PRAIRIE ISLAND NUCLEAR GENERATING PLANT UNIT NO. 1

AMENDMENT TO FACILITY OPERATING LICENSE

Amendment No. 52
License No. DPR-42

SAFETY EVALUATION BY THE OFFICE OF NUCLEAR REACTOR REGULATION
RELATED TO AMENDMENT NO. 52 TO FACILITY OPERATING LICENSE NO. DPR-42
AND AMENDMENT NO. 46 TO FACILITY OPERATING LICENSE NO. DPR-60
NORTHERN STATES POWER COMPANY
PRAIRIE ISLAND NUCLEAR GENERATING PLANT, UNIT NOS. 1 AND 2
DOCKET NOS. 50-282 AND 50-306

FIGURE 3.1-5

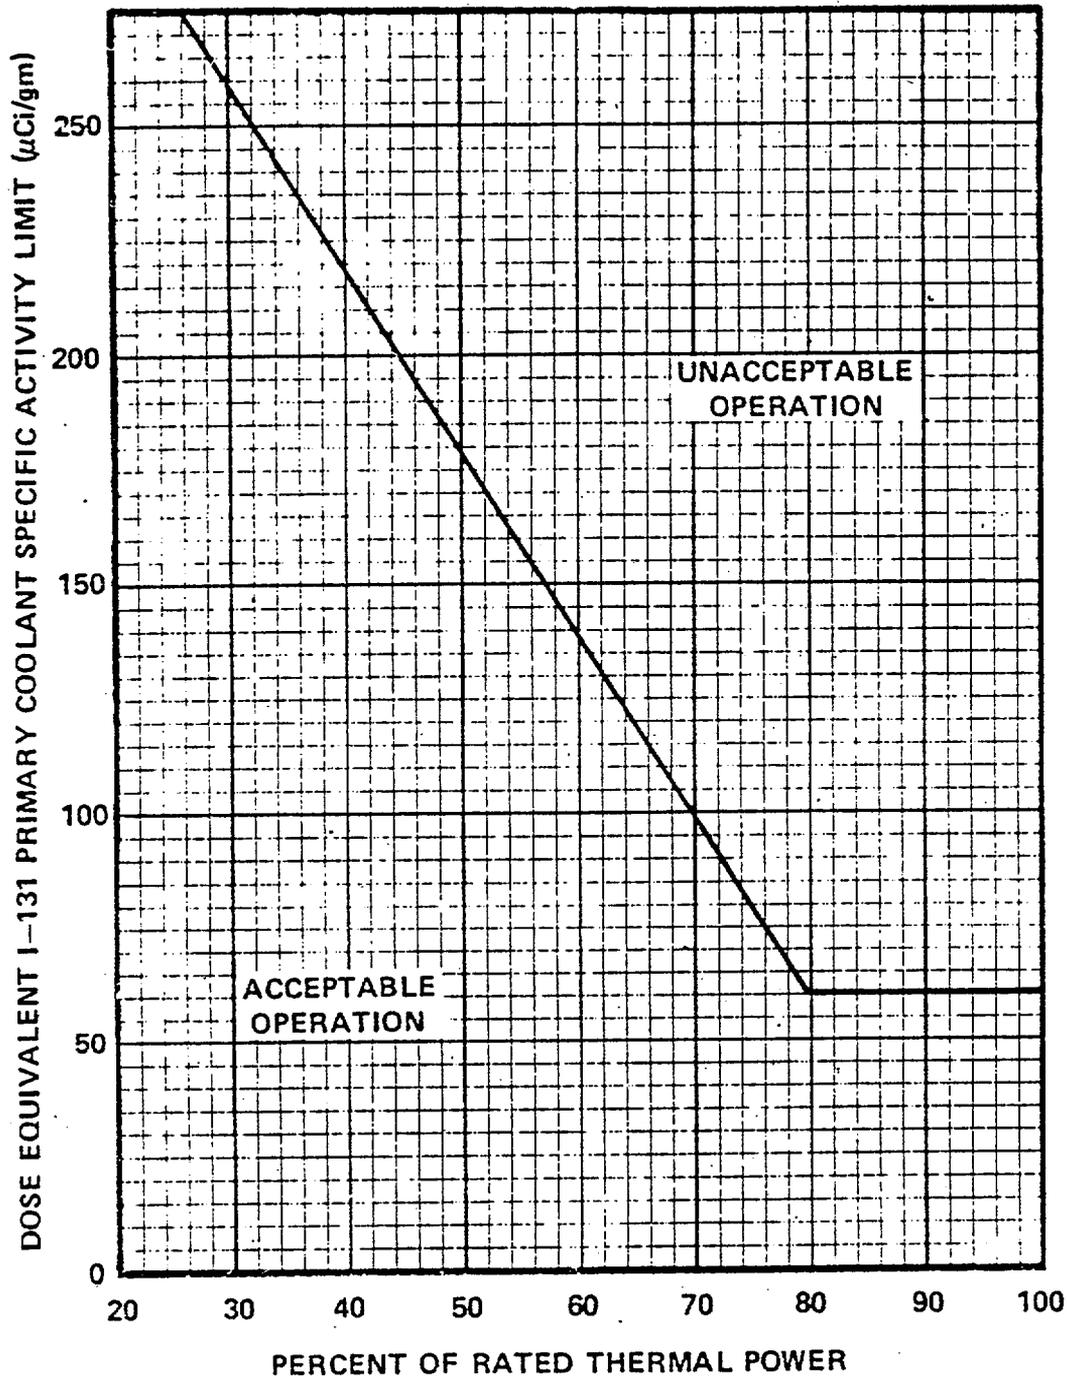
3. If a reactor is above hot shutdown and RCS temperature is greater than or equal to 500°F:
 - (a) With the specific activity of the primary coolant greater than 1.0 microcurie per gram DOSE EQUIVALENT I-131 but within the allowable limit (below and to the left of the line) shown on Figure TS.3.1-5, operation may continue for up to 48 hours provided that the cumulative operating time under these circumstances does not exceed 800 hours in any consecutive 12-month period. With the total cumulative operating time at a primary coolant specific activity greater than 1.0 microcurie per gram DOSE EQUIVALENT I-131 exceeding 500 hours in any consecutive 6-month period, a special report to the Commission shall be submitted within 30 days indicating the number of hours above this limit.

- (b) With the specific activity of the primary coolant greater than 1.0 microcurie per gram DOSE EQUIVALENT I-131 for more than 48 hours during one continuous time interval or exceeding the limit line shown on Figure TS.3.1-5, the affected reactor shall be shutdown and RCS temperature cooled to 500°F or less within 6 hours.

Specification 3.1.D.2, permitting power operation to continue for limited time periods with the primary coolant's specific activity greater than 1.0 microcuries/gram DOSE EQUIVALENT I-131, but within the allowable limit shown on Figure TS.3.1-5, accommodates possible iodine spiking phenomenon which may occur following changes in thermal power. Operation with specific activity levels exceeding 1.0 microcuries/gram DOSE EQUIVALENT I-131 but within the limits shown on Figure TS.3.1-5 must be restricted to no more than 800 hours per year (approximately 10 percent of the unit's yearly operating time) since the activity levels allowed by

Figure TS.3.1-5 increase the 2 hours thyroid dose at the site boundary by a factor of up to 20 following a postulated steam generator tube rupture. The reporting of cumulative operating time over 500 hours in any 6 month consecutive period with greater than 1.0 microcuries/gram DOSE EQUIVALENT I-131 will allow sufficient time for Commission evaluation of the circumstances prior to reaching the 800 hour limit.
